Styllent Knit Limited

5 March 2024

2. Observations

Observation 1: Inadequate number of concrete cylinder test report (Main Production Building).

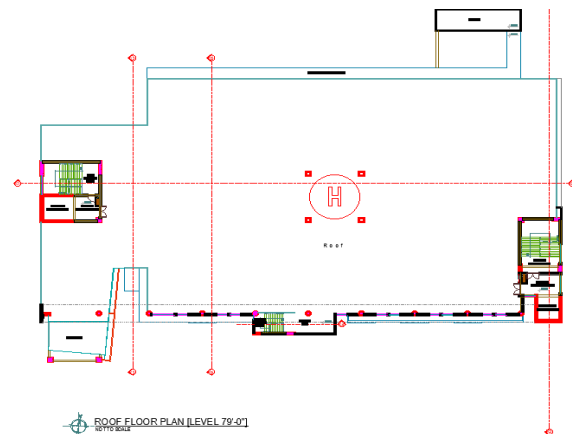
Description: The design strength of all structural members is used as 24.13 MPa (3500 psi). At the time of inspection 16-concrete cylinder test report was available from foundation which doesn't meet the frequency of testing (BNBC). The building engineer is required to check and confirm the design strength by reviewing the existing cylinder test data according to the BNBC. If the existing cylinder test data does not satisfy the BNBC 5.12, confirm the concrete strength by taking 100 mm diameter core (minimum 4 nos.) from lower tier columns. Update the design report as per the in-situ material strength following BNBC 1.9.1.

ROOF FLOOR PLAN (LEVEL 79'-0")

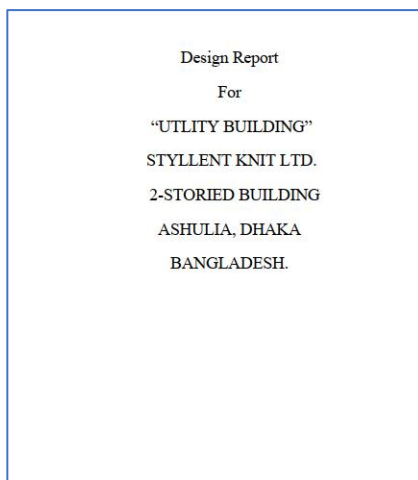
Description: Two undocumented plastic water tanks (5000-liter capacity each) were found on the roof slab. Also, steel column is shown at marked location, but no such column was found. The building engineer is required to update the as-built drawing and consider it in the design check.
